ONE SYDNEY HARBOUR

BARANGAROO

R4A SUPPLEMENTARY DESIGN STATEMENT FOR S4.55 MODIFICATION APPLICATION
June 2021

R4A Site Plan - Proposed

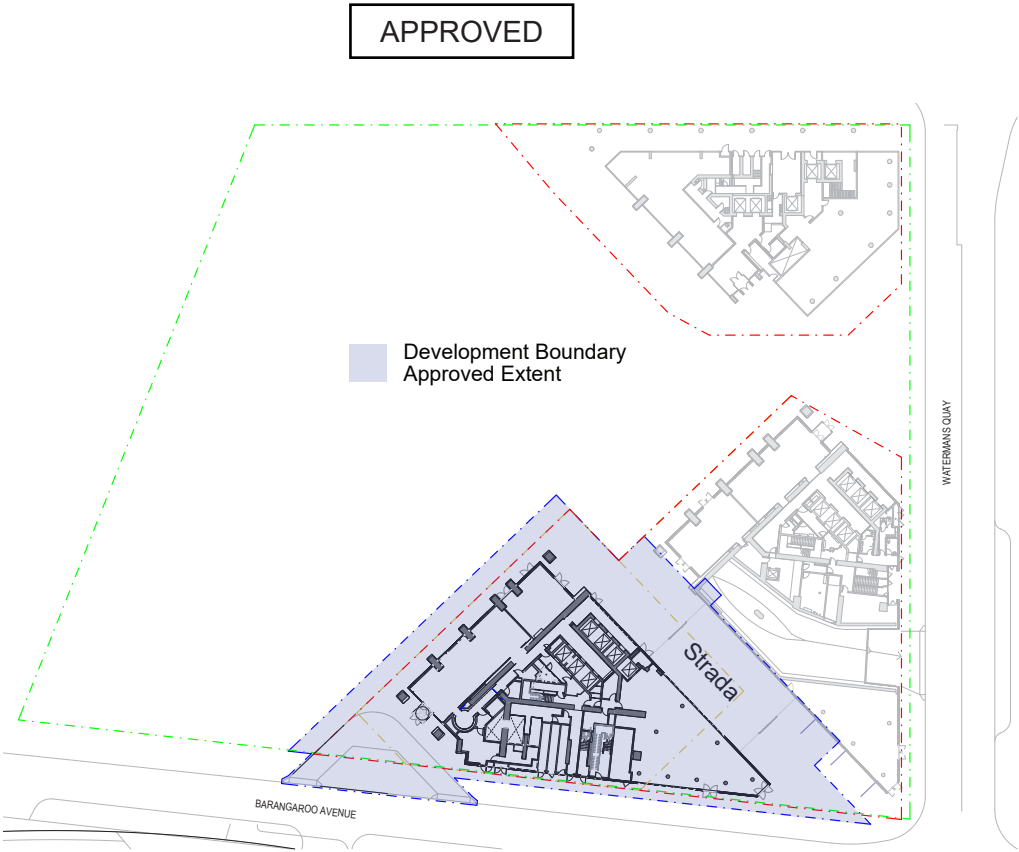
Through this planning amendment it is proposed to transfer the approval of the Strada ground plane from the Building R4A Development Consent (SSD 6964) to the Building R4B Development Consent (SSD 6965) so that the entirety of the Strada (including the ground plane and the roof structure above) sits within the same development consent being Building R4B.

As a result, the development application boundary extent has been revised, and an administrative transfer of conditions which relate to the Strada is also proposed as part of this modification.

Proposed GF Landscape Plan

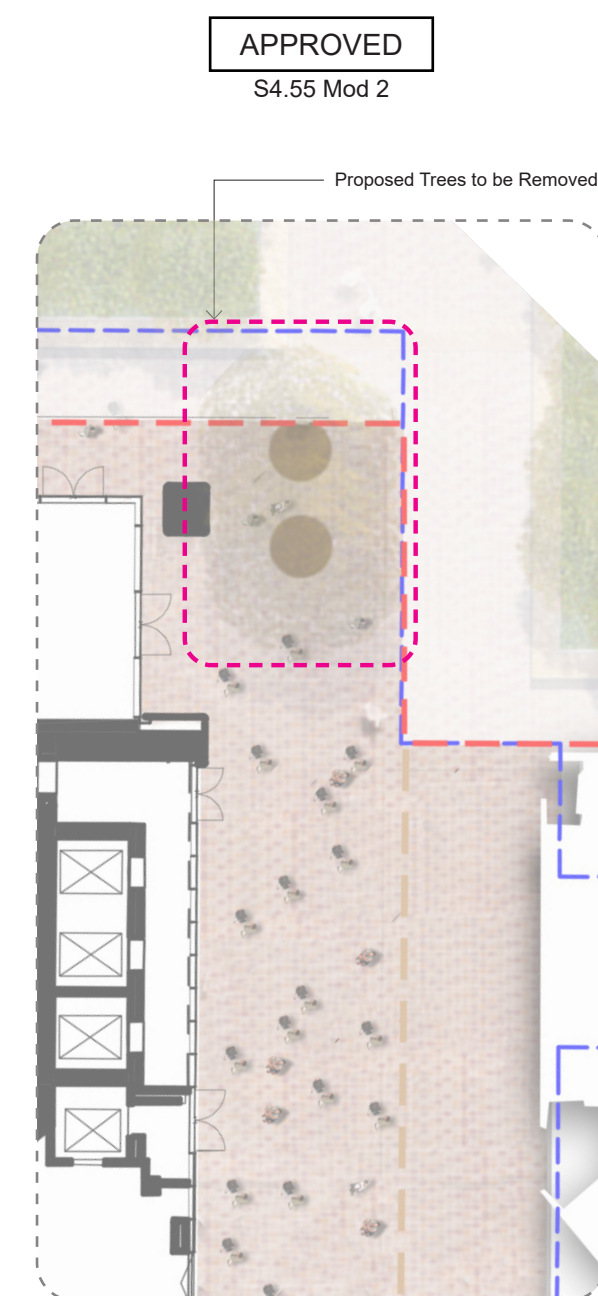
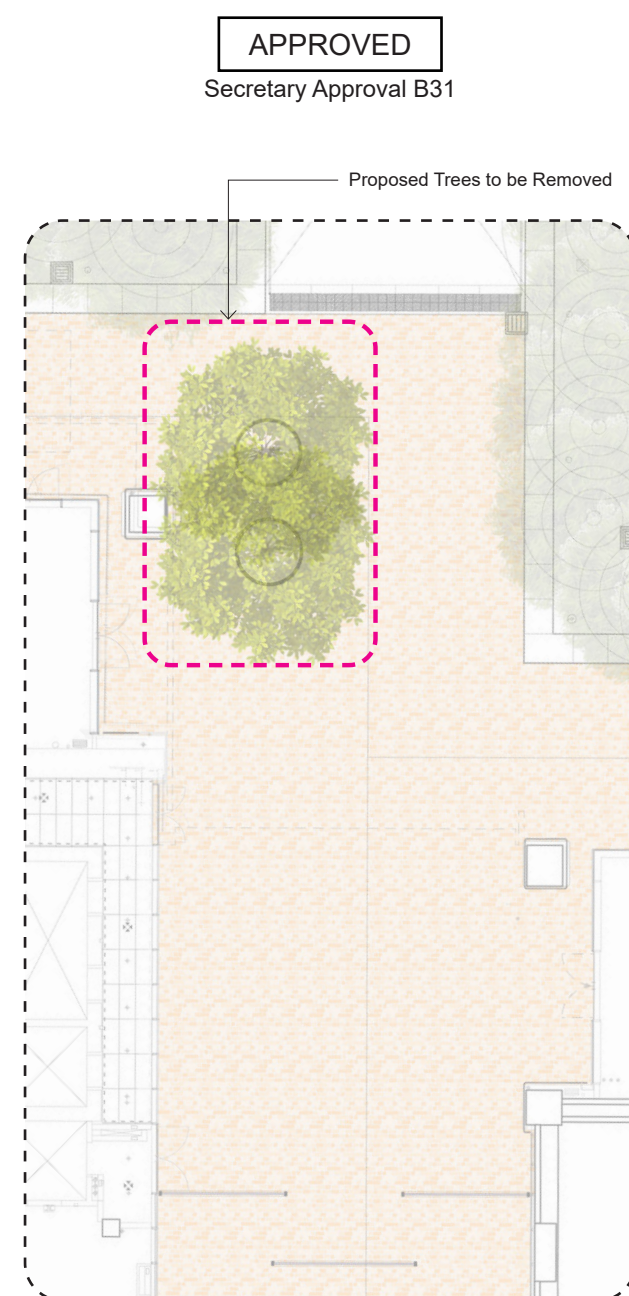
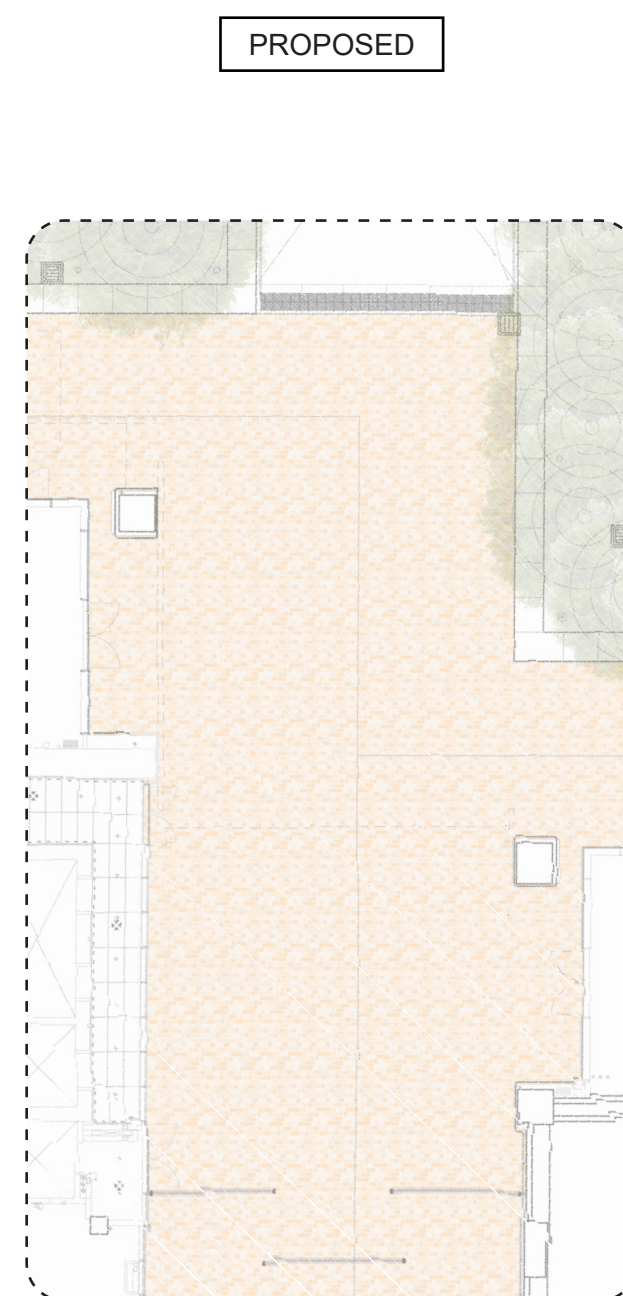
Two trees adjacent to the parkside tenancy and at the entry to Hickson Park are included in the approved landscape plan shown on the left.

This proposal seeks to remove the two trees for the following reasons.

The two trees were located in the original development consent for Building R4A (2017), prior to the design and approval of the adjoining Barangaroo Public Domain (SSD 7944), including Hickson Park in 2018. Hickson Park includes 65 trees, including 53 in a 'tree belt' directly adjacent to the Towers and 12 in the broader Park area. The public domain areas around the Towers to the Hickson Park frontage are generally open paved areas, and 'frame' the tree belt. These two trees therefore are not consistent with the ground plane character around the Towers to Hickson Park, and their removal would provide a more consistent public domain outcome

Further, the impact of the two trees on the wind mitigation is negligible. The tree belt in Hickson Park provides significant tree planting with soil zones and clear space to support developed trees in height and canopy to assist with the wind mitigation for this area. The two trees proposed to be removed will have a restricted canopy in this location.

The removal of these trees will ensure also clear pedestrian access at the entry to Hickson Park and improve visual connectivity from Hickson Park through to the Strada. In addition, the visual and ecological loss of those two trees is managed with the significant degree of tree planting approved through the Barangaroo Public Domain SSD 7944, especially the trees in adjoining Hickson Park.

Proposed Entry vestibule - Plan

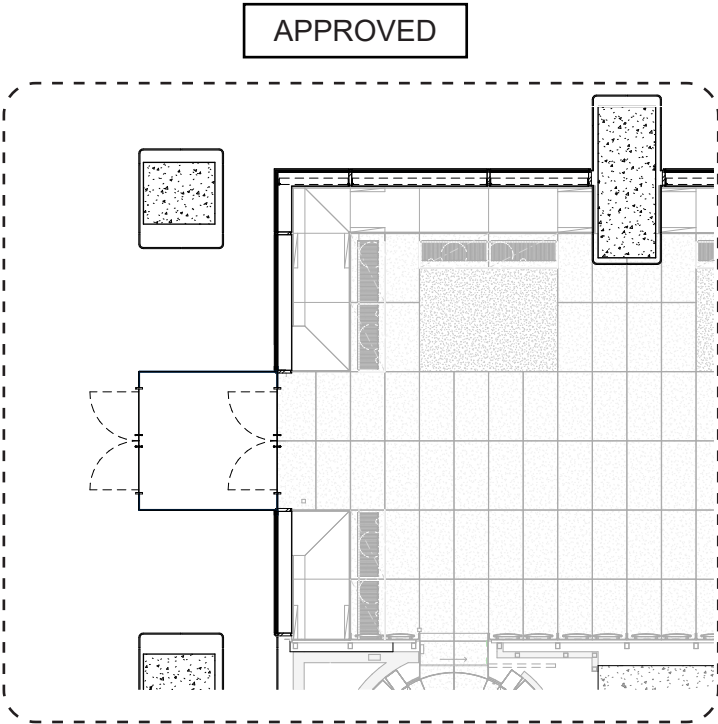
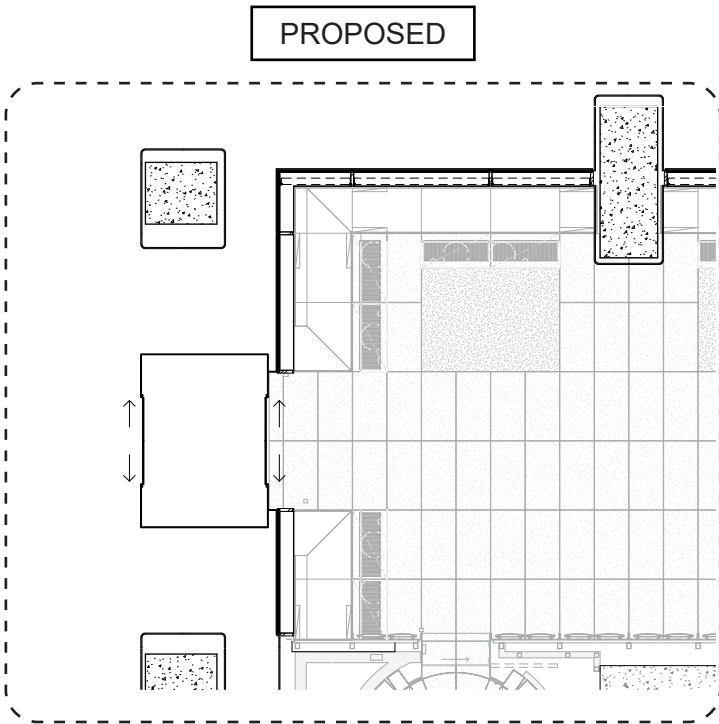
Automated sliding doors have been integrated in lieu of swing doors, improving operability as well as creating a seamless transition from outside to the residential lobby interior.

Through detailed review with the project consultant team it has been determined that a sliding door system would provide a more robust, reliable and fit-for purpose solution.

This amendment has resulted in a minor adjustment to the dimensions of the lobby vestibule. This amendment has been integrated into the modulation, proportion and geometry of the facade to provide a design response that meets the design standards of the precinct architecture.

PROPOSED

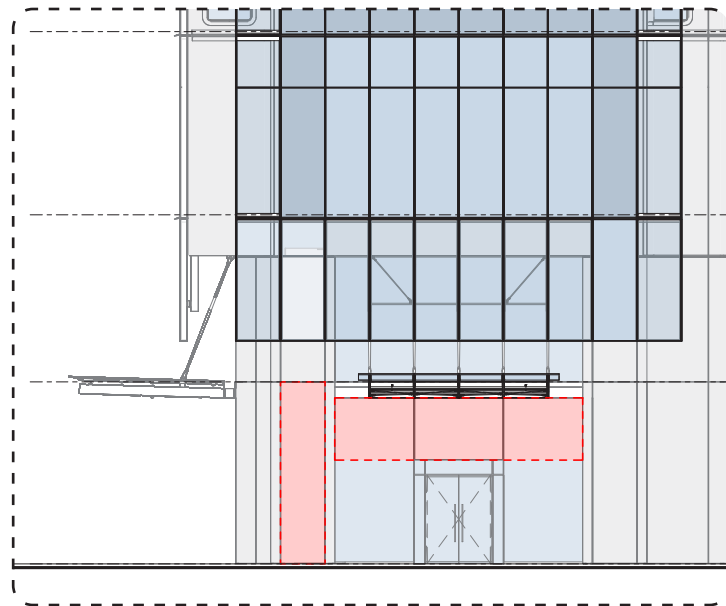
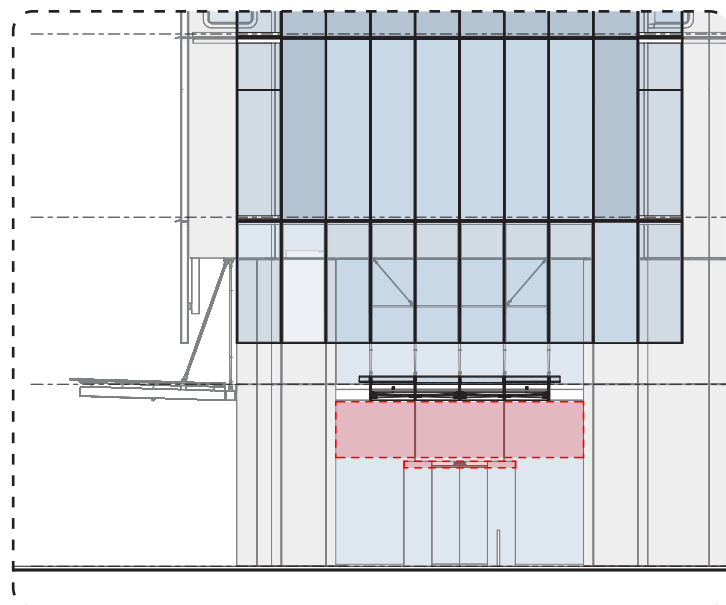
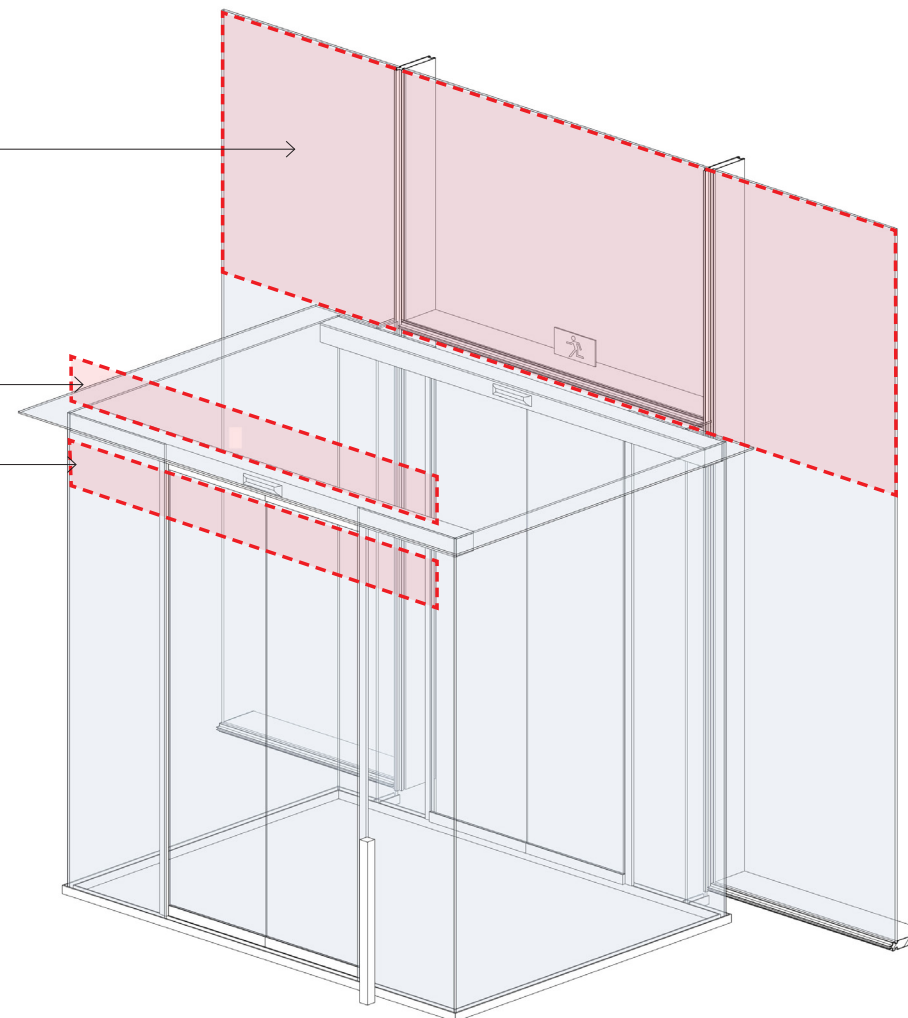
Further detailed development on building signage has been undertaken and it is proposed to revise the location of the entry vestibule signage zone as shown on the left.

The already approved zone above the entry vestibule box has been extended to include a potential signage on the glass above the door.

Depending on the final design the signage may be located either on the glass or above the vestibule volume.

In addition, the secondary approved signage zone located on the adjacent column is no longer deemed to be required and has been removed.

Proposed L58 Plan - Upper Floor Plate

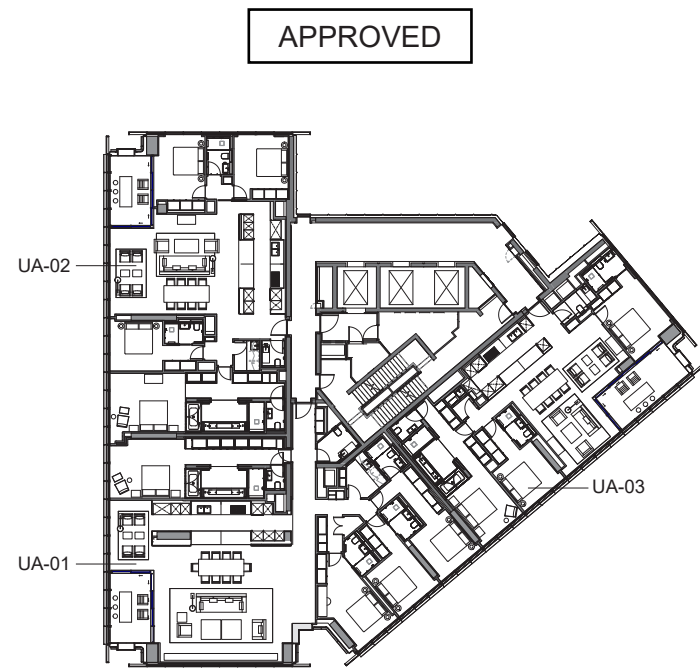
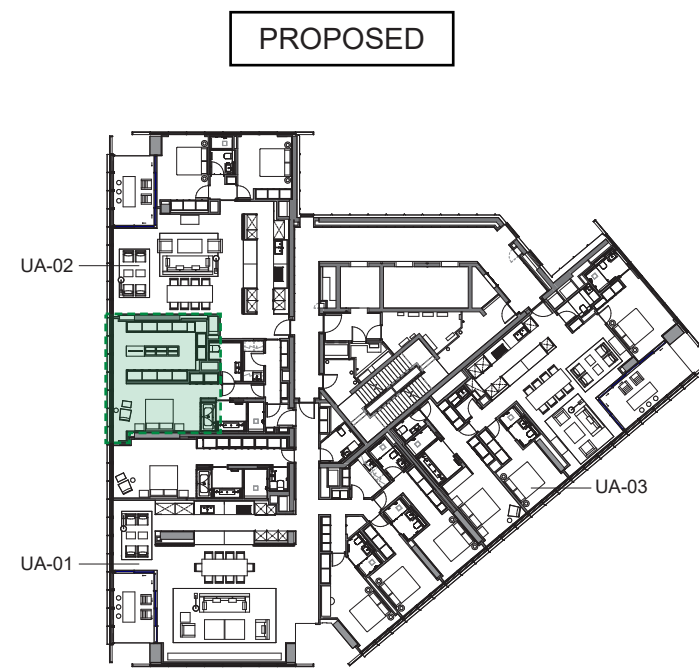
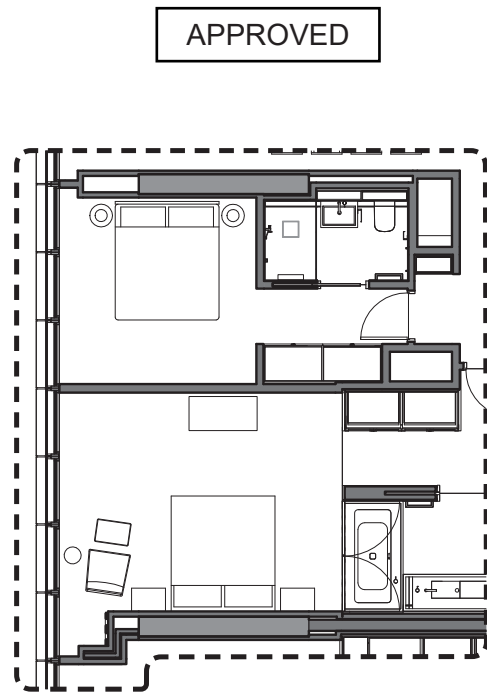
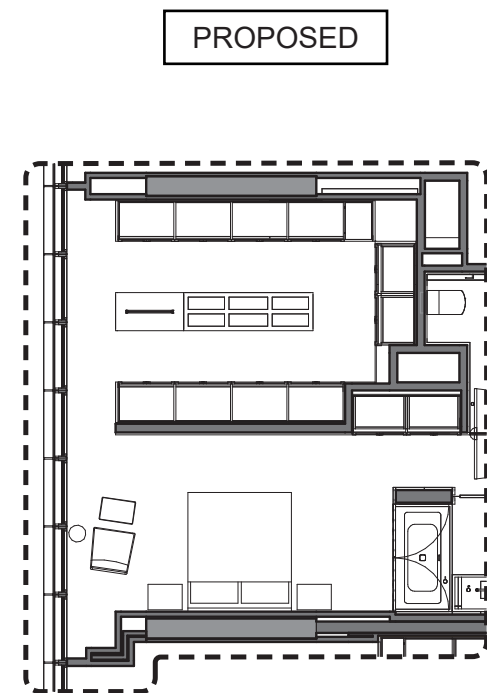
A minor internal layout modification is proposed for the Level 58 UA-02 apartment through the creation of a walk-in-robe to the master bedroom in lieu of a secondary bedroom, reducing the overall bedroom count from 4 to 3. This proposed change has been part of a design refinement process to cater to specific purchaser needs whilst ensuring a high quality overall apartment design is maintained
